TECHNICAL CIRCULAR

DOC No.: HHI-TEC-0457

**SUBJECT: STANDARD TOOL OF EXHAUST VALVE GRINDING
MACHINE FOR EXHAUST VALVE SPINDLE AND SEAT
ON NEW MAN-ES ENGINES**

TYPE: ALL HYUNDAI-MAN B&W 2-STROKE ENGINES

Figure: Exhaust valve bottom piece design

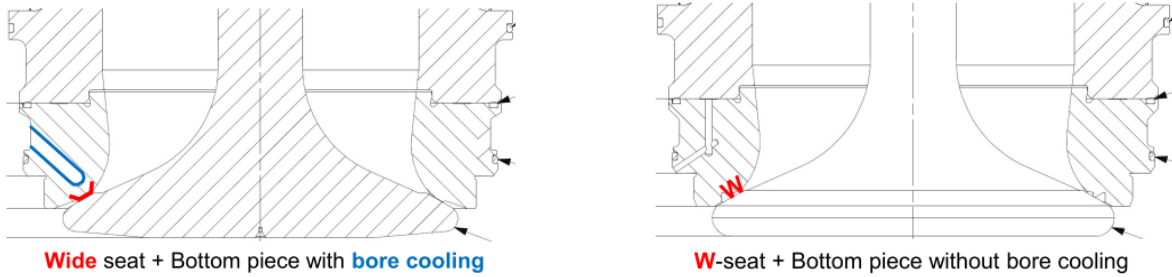
The one of reason was that the W-seat design of exhaust valve bottom piece has an ability to minimize the dent mark size compared to the wide-seat design, and the W-seat also excellent on the ability to crush seat deposits meaning that the W-seat are more forgiving if the seat contact are not kept clean. Furthermore the W-seat has an ability to make firm seat contact on both seats in the contact, even if the seat angle difference between spindle and bottom piece are slightly out of Spec.

However, the W-seat has one major drawback, being that the spindle cooling are diminished due to the minor thermal seat contact, compared to wide-seat.

According to the trend of engine development, the combustion process has developed in a direction that put more and more heat load on the exhaust valve spindle. This development has been forced to re-introduce the wide seat design in order to avoid too short spindle service life due to the disc bottom burn-off. Therefore, it has been specified wide seat bottom piece on newbuilding's within the 50-70 bore segment since the beginning of 2014. Since mid-2016, the wide seat design has been standard on all newbuilding's regardless bore size. The bore cooled wide seat bottom piece and optimized seat angle was introduces primo 2019 in newbuilding's.

The ongoing trend of increased combustion chamber heat load has been forced to prioritize wide-seat design, in order to make sufficient spindle cooling, making the spindle bottom burn-off rate endurable. Also the enhanced cooling with wide seat, will make it possible to keep the spindle seat maximum temperature below a threshold limit.

However, a number of spindles suffering from the blow-by has been seen after having been in service for several years by applying wide seat design. We find that in case the spindle bottom burn-off rate are in the lower range, then the increasing number of dent marks that are accumulated on the seat's during service will most likely be the cause of reduced lifespan if not addressed.

Therefore, the exhaust valve grinding machine for exhaust valve spindle and seat will be introduced as a standard tool for new ordered all Hyundai-MAN B&W 2-Stroke engines since it is worthwhile to carry out seat preventive grinding. Preventive grinding of exhaust valve spindle seat and bottom piece has more advantage compares to the spindle reconditioning. This tool can be provided with extra cost for the ongoing projects, if requested.
